A neighborhood steering committee met 2 Dec, 16 Dec and 9 Jan to discuss issues surrounding Core Space's proposed development at 126 Langdon St. The committee is concerned that the proposal does not conform to the zoning for the location. There are features of the proposal that the committee feels are inappropriate for the historically collegiate neighborhood very closely associated with UW-Madison campus. The steering committee recognizes that the Urban Design Commission is empowered to influence the design of the proposed development for 126 Langdon. We would like the commissioners to consider the following.

Please review the attached drawing comparing the front façade of the proposed development to that of adjacent buildings on Langdon St.

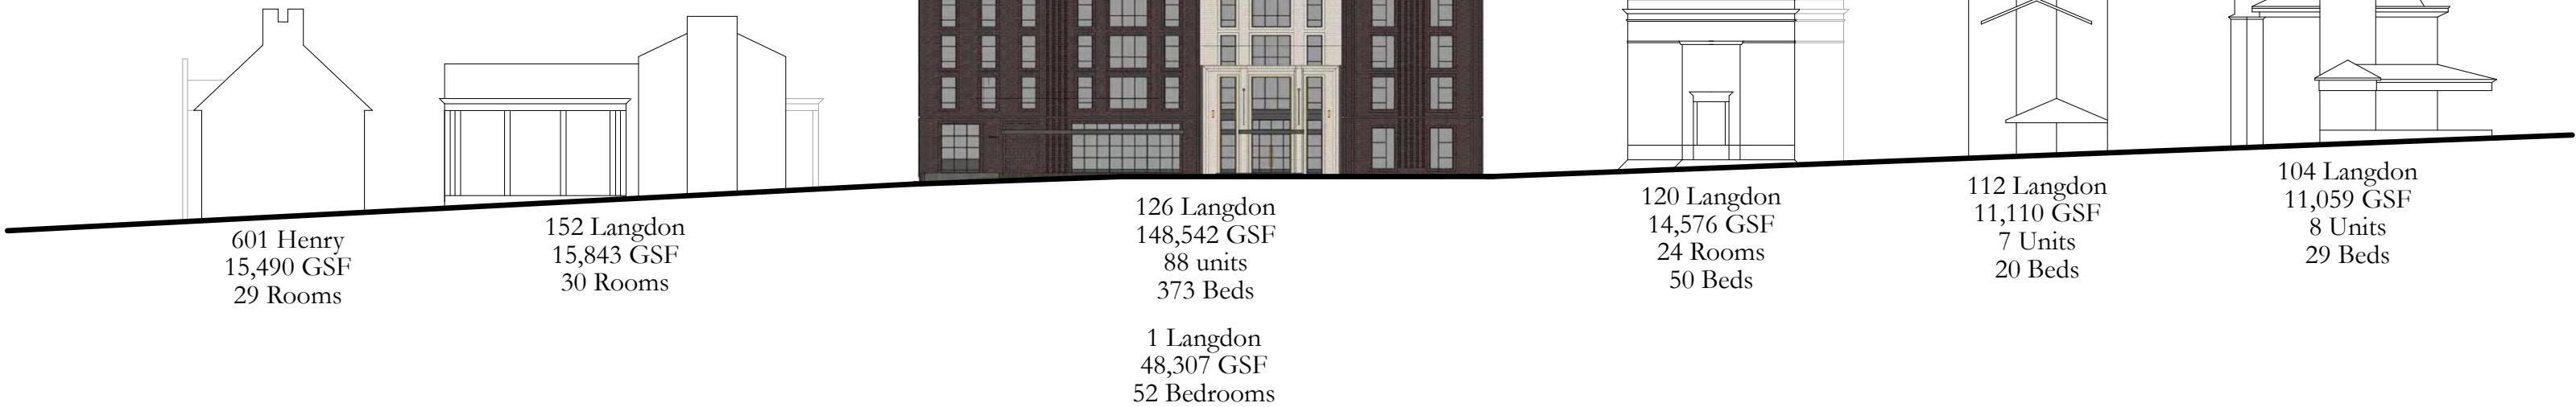
The first is the mass of the proposed building and its commercial appearance. The size of the front elevation is out of scale with respect to adjacent buildings and appears to be more appropriate for a location for a mixed-use development. There is little in the design that brings out the residential character found in Kennedy Manor or in the new Evans Scholar building.

Another example of this lack of integration is just across from the proposed 9-story northwest elevation is 130 Langdon, Pi Beta Phi, a 3-story contributing building in the National Register Historic District on the lake. The Commission must evaluate whether the bonus 2 stories resulting in a contemporary 9 story building should be directly next to a traditional 3-story historic building.

A design with much deeper articulation and less vertical height on the front elevation would address the committee's concerns about the aesthetics of the design. UDC's review of this design is important for maintaining the architectural harmony of this historic neighborhood. The steering committee did not feel that the building design met the City's criteria for a bonus 2 stories.
